ADDENDUM NO. #0

TRACK & FIELD IMPROVEMENTS

Channel Islands High School

April 10, 2020

AD0-L2

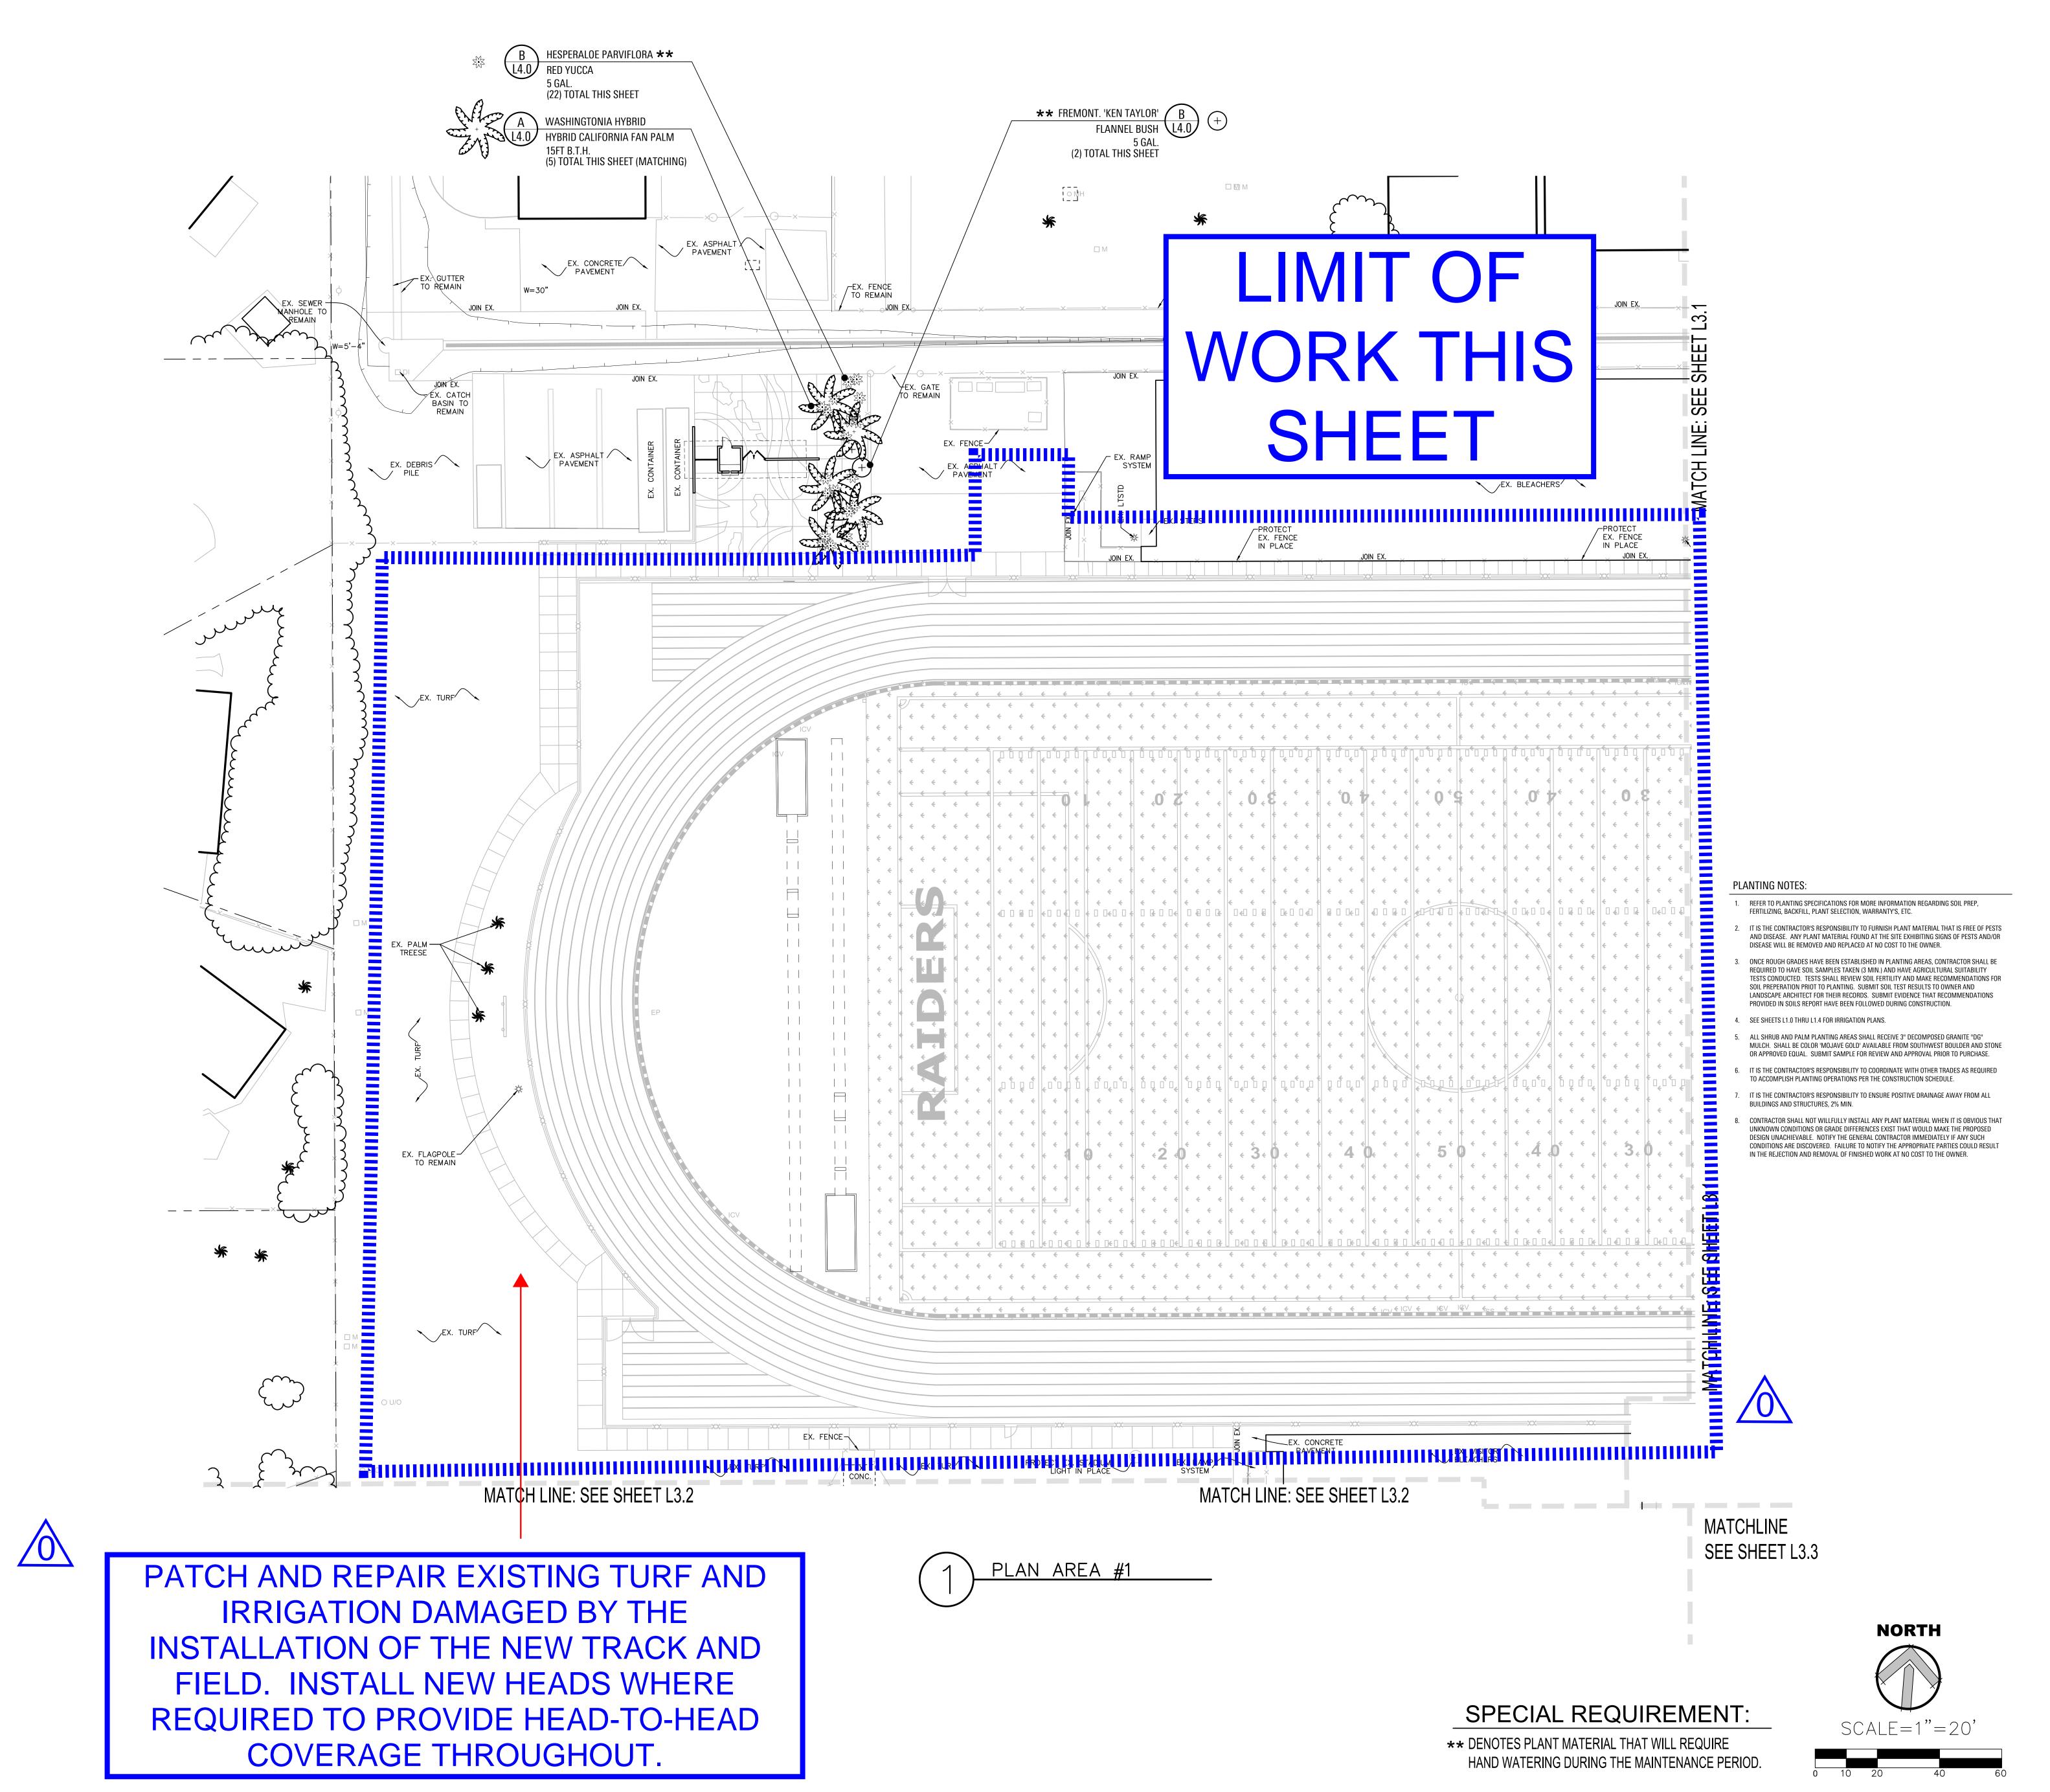
- **3.2.2.2.** Drawing L1.1/AD0-L2 Area of work has been revised as shown on this sheet. Notes added to indicate mainline and sleeve crossing new track with connection to existing irrigation loop. Contractor also needs to provide an allowance to repair/replace existing irrigation damaged by POT improvements around edge of track.
